SIB 64 03 20

2020-09-28

CENTER CONSOLE / CUP HOLDER GETS HOT WHEN THE HEAT IS ON

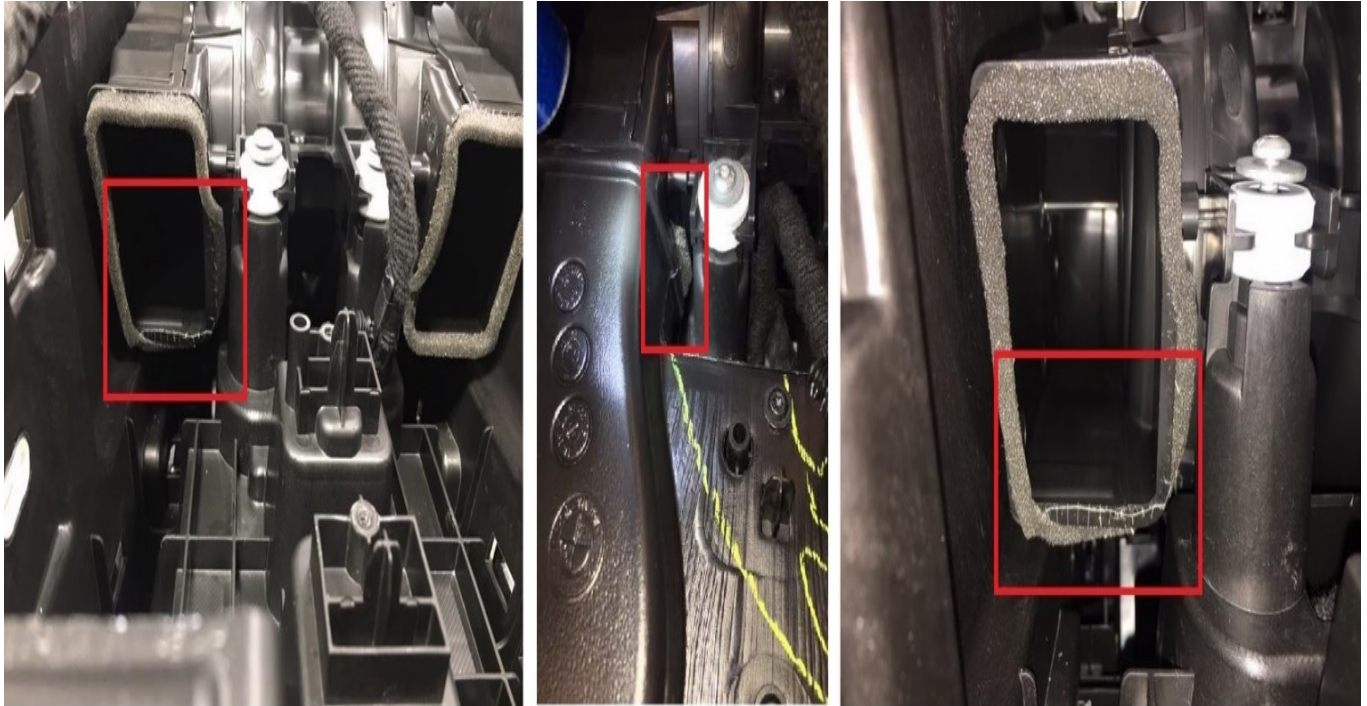
The foam material that seals between the ducts may be out of position, not held by the mounting adhesive and squashed allowing for an air leak. This leak can occur at any of these 6 junction locations:

1-Check foam seal material at duct connections and replace foam as needed. Ensure ducts are properly overlapped on installation.

2-Replace rear air ducts.

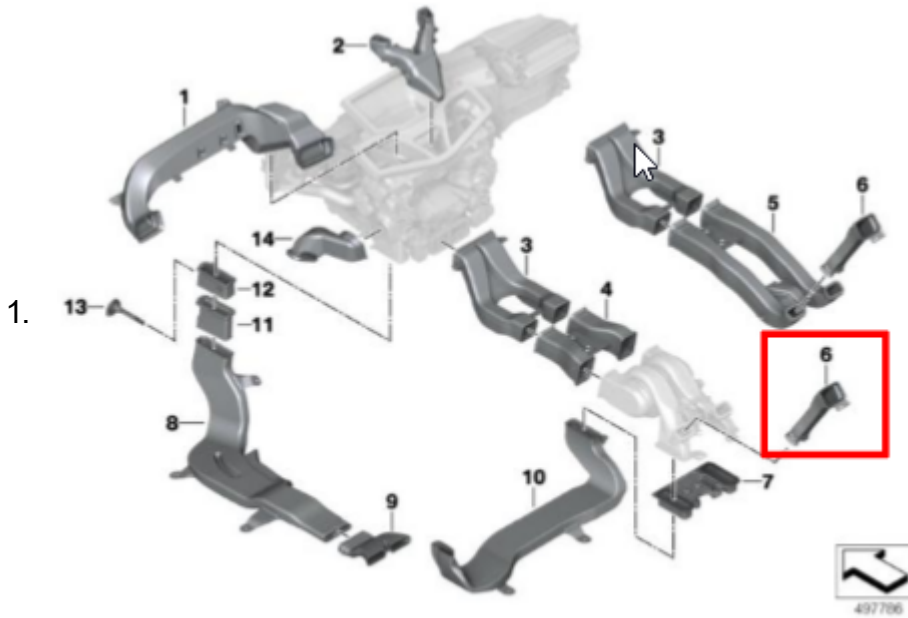
Not OK: Blower Assembly foam insulation found rolled, not positioned in correct, location allowing air to leak.

Not OK: Center duct is not overlapping assembly. Allowing Air to leak.

OK: Blower Assy. foam insulation in right position.

OK: Center duct is overlapping blower assy.

2. Check if the foam material to the next connecting piece is correctly installed. If damaged install a locally sourced, one side self-adhesive
